ADDENDUM NO. 2

DATE OF ISSUANCE: 7/21/2026

PROJECT: AUTOMOTIVE TECHNOLOGY CENTER RELOCATION AND RENOVATION
8204 HWY 311, SELLERSBURG IN, 47172

ARCHITECT'S PROJECT NO.: 26-064

A 322
PROJECT NUMBER
26-064.001
ALL SHEETS INTENDED FOR COLOR PLOT. VERIFY BLACK
AND WHITE PLOT FOR INFORMATION INTEGRITY

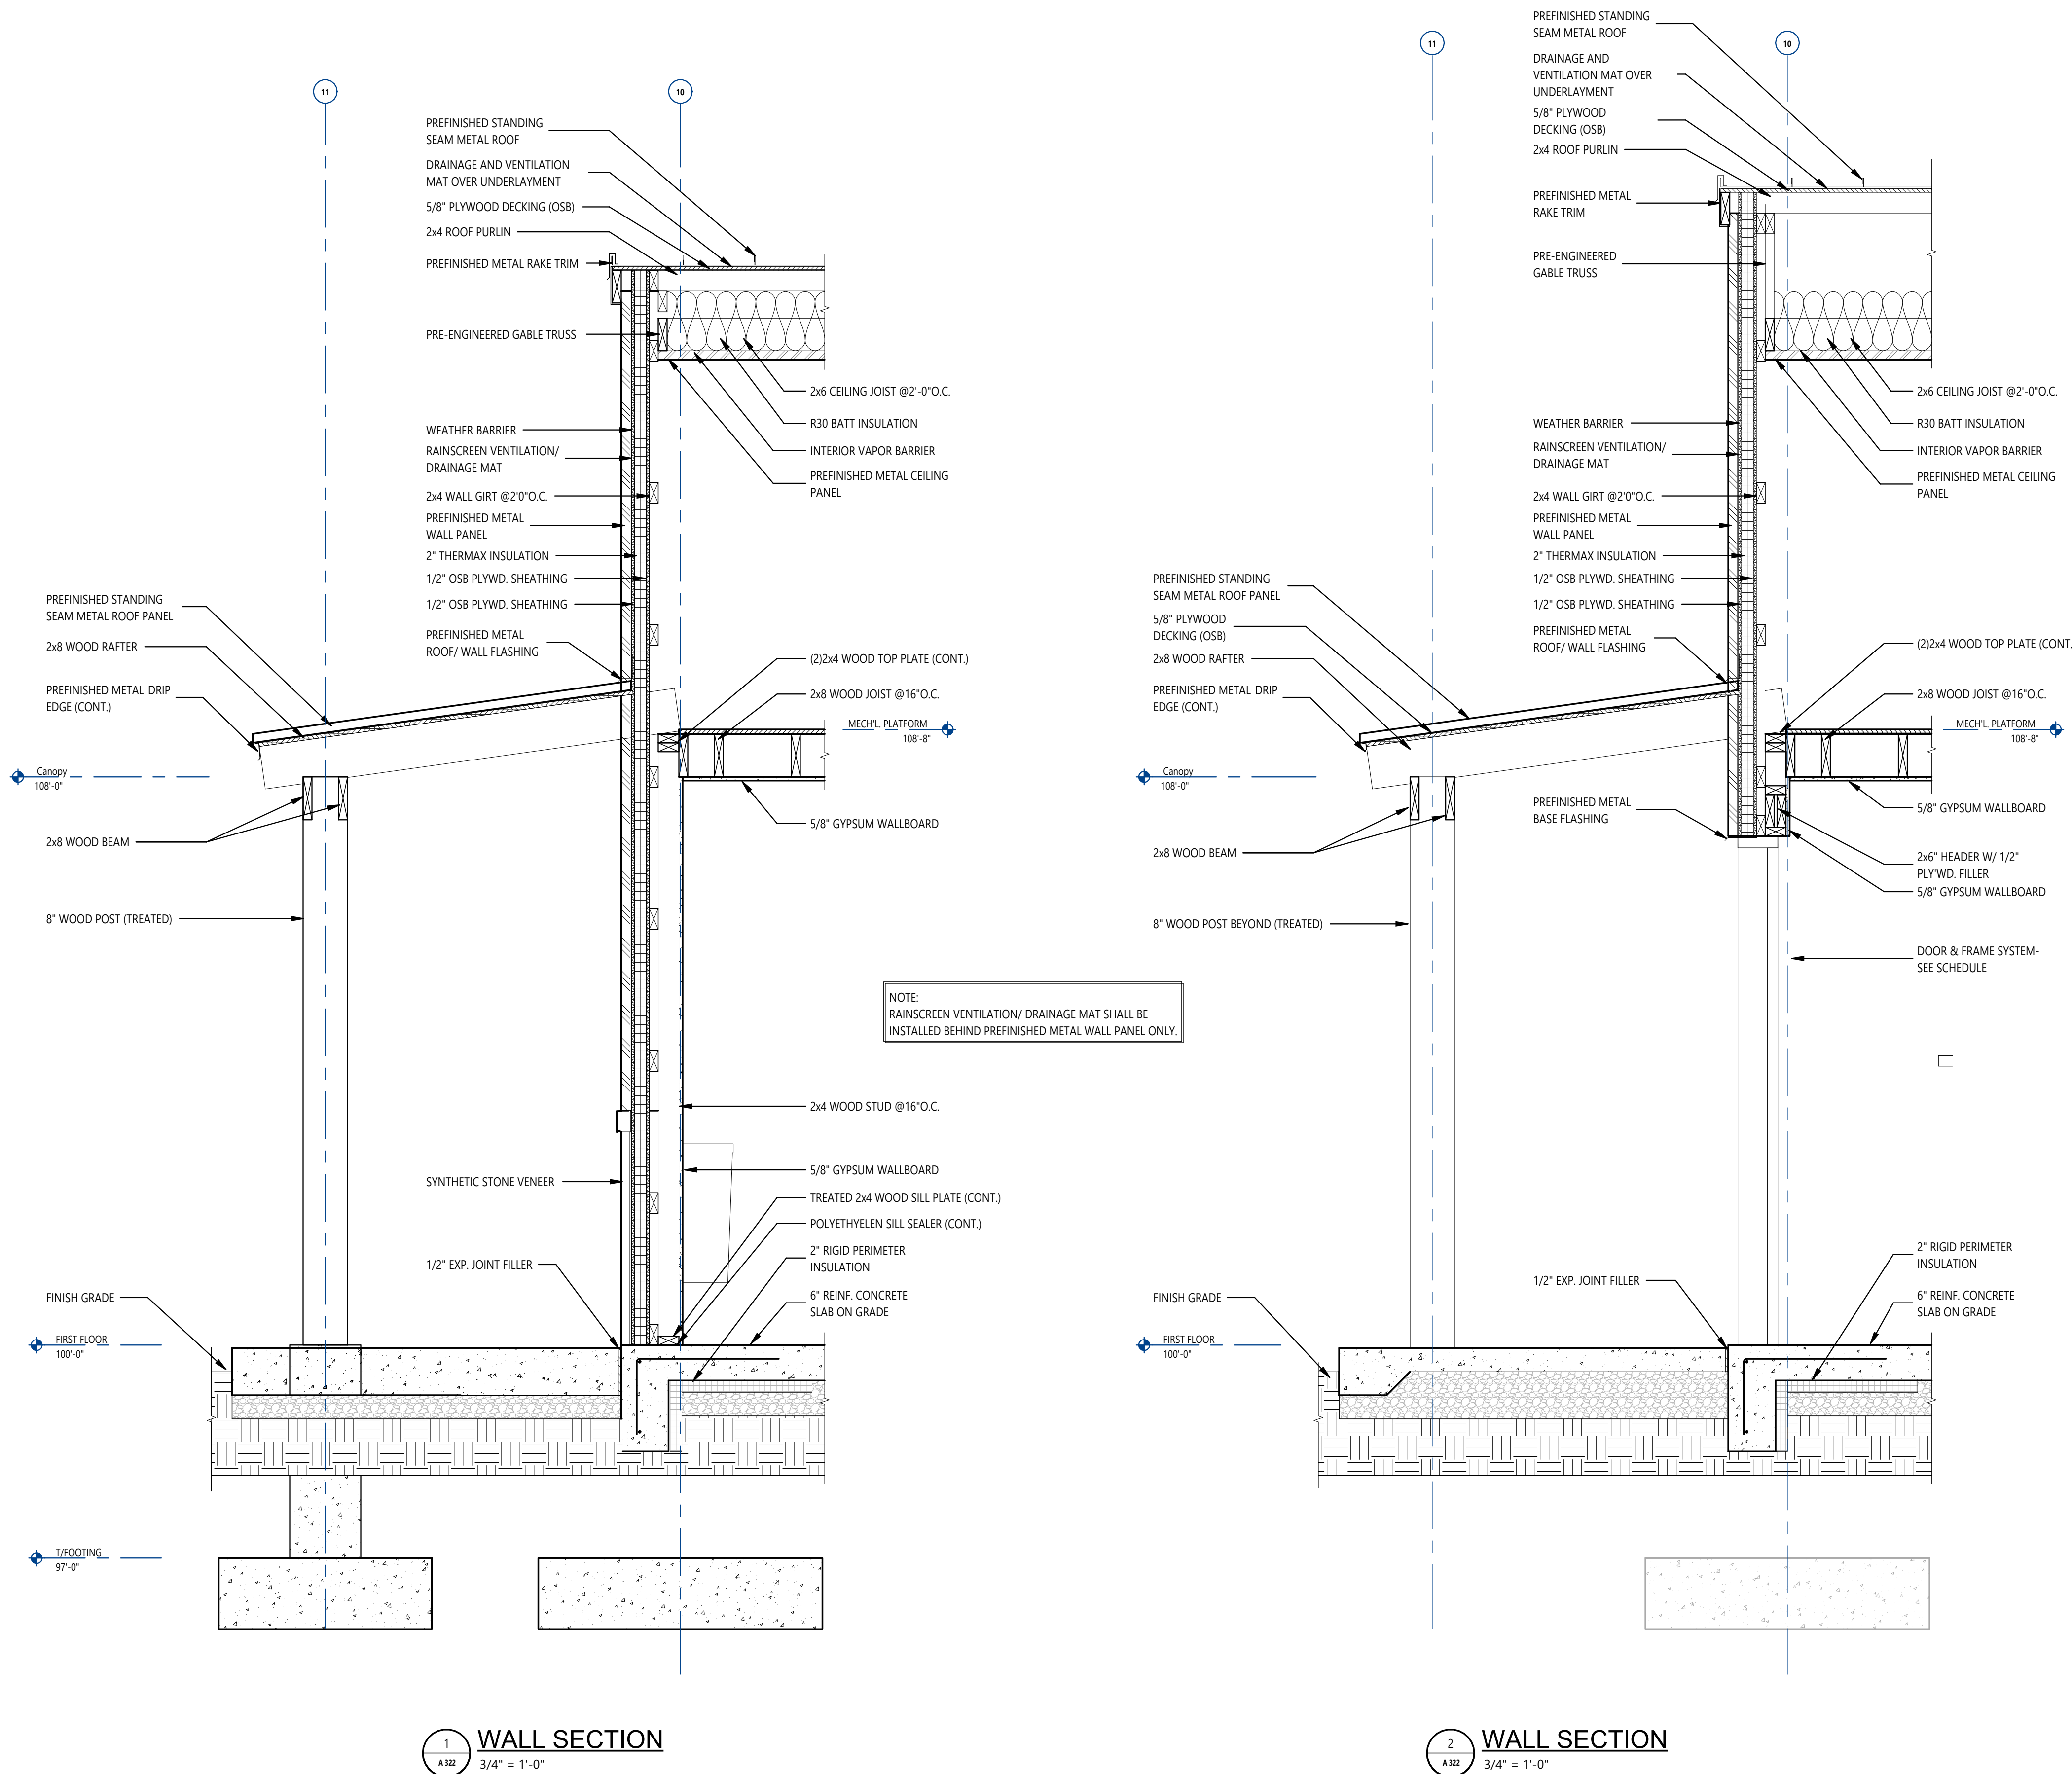
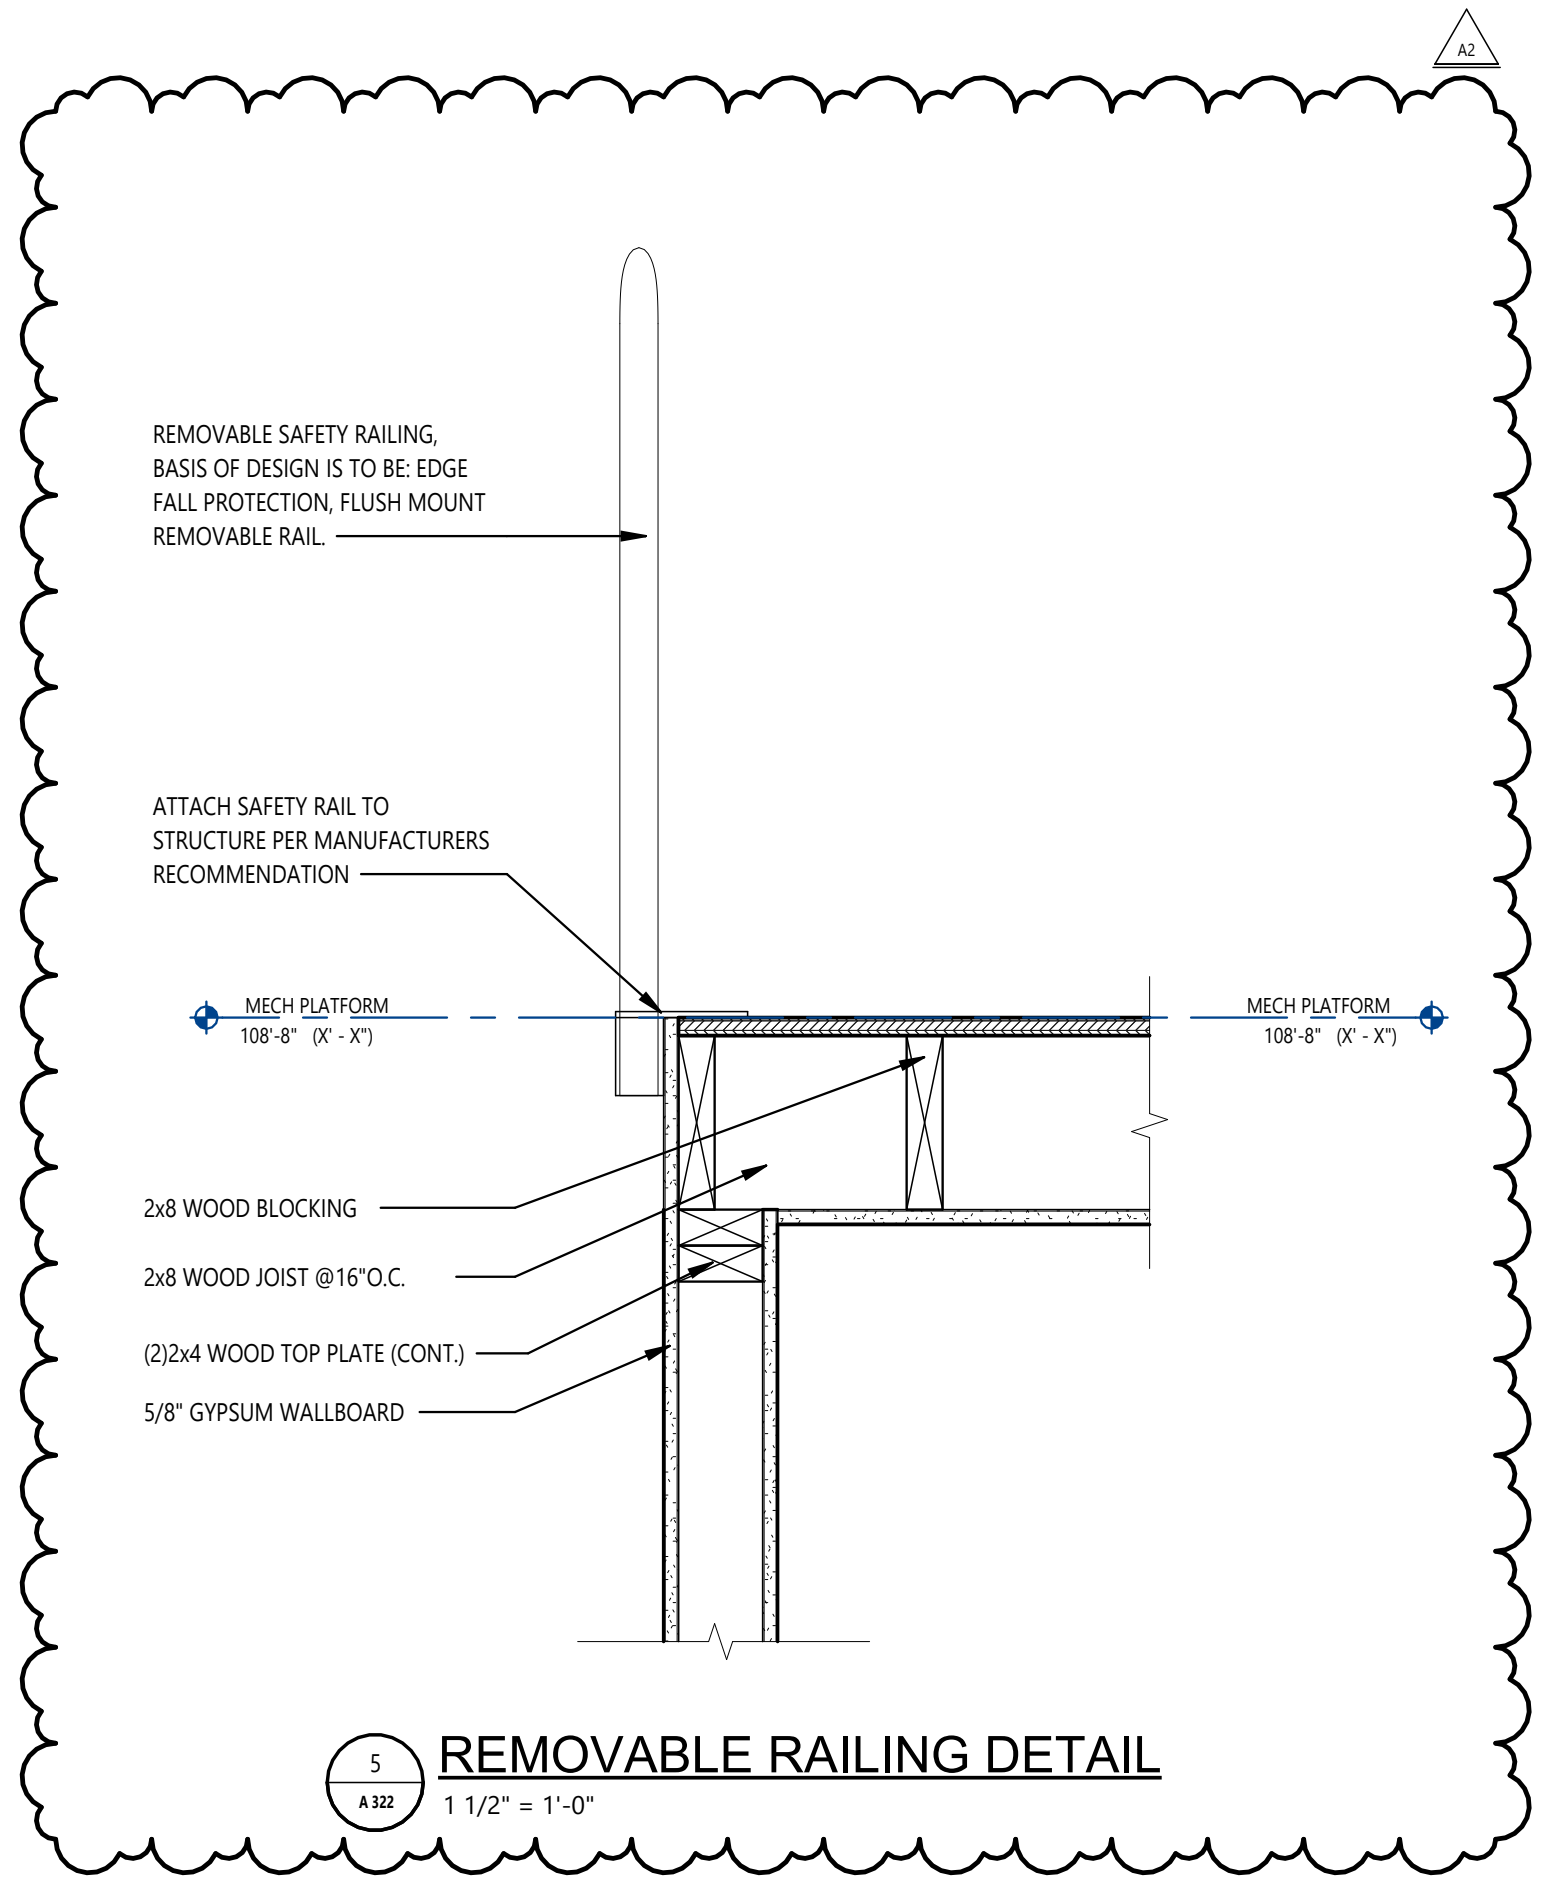
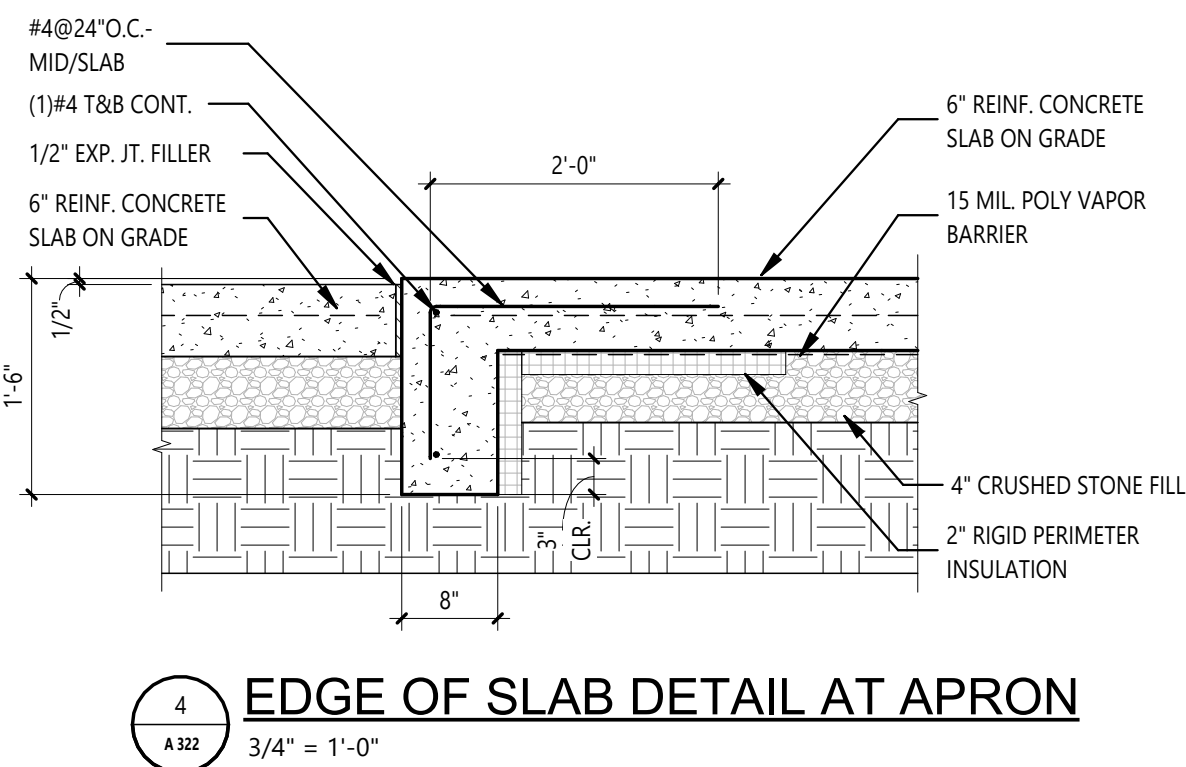
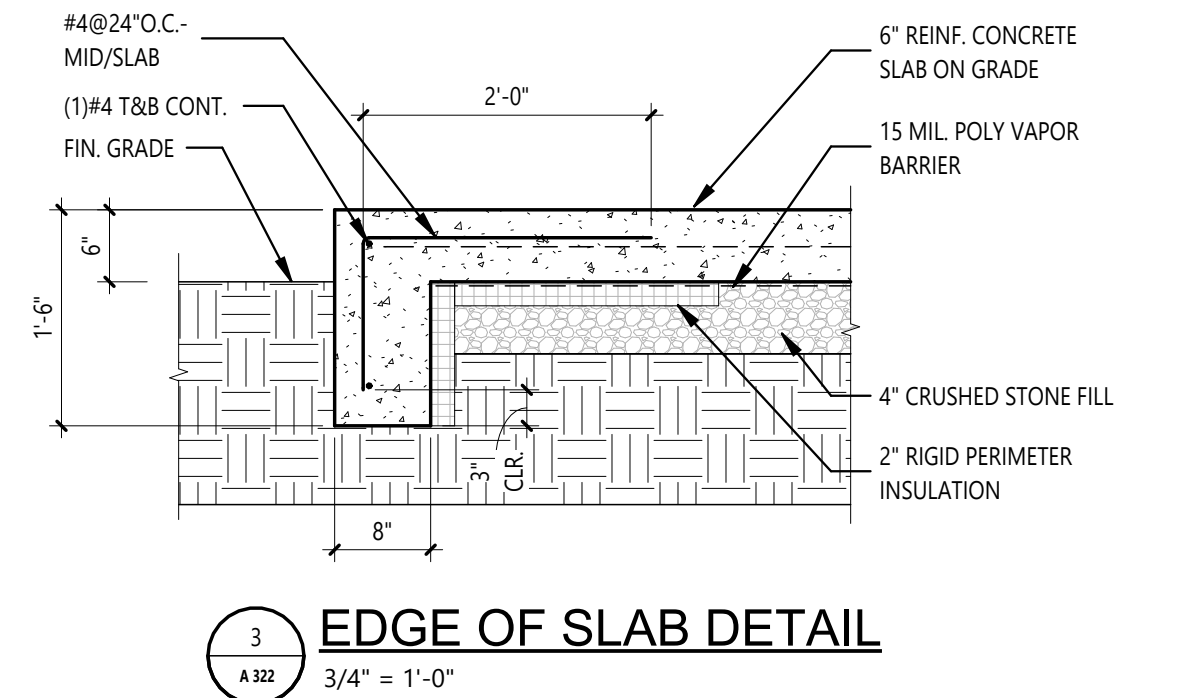
ADD-2: A 322

Added removable safety railing
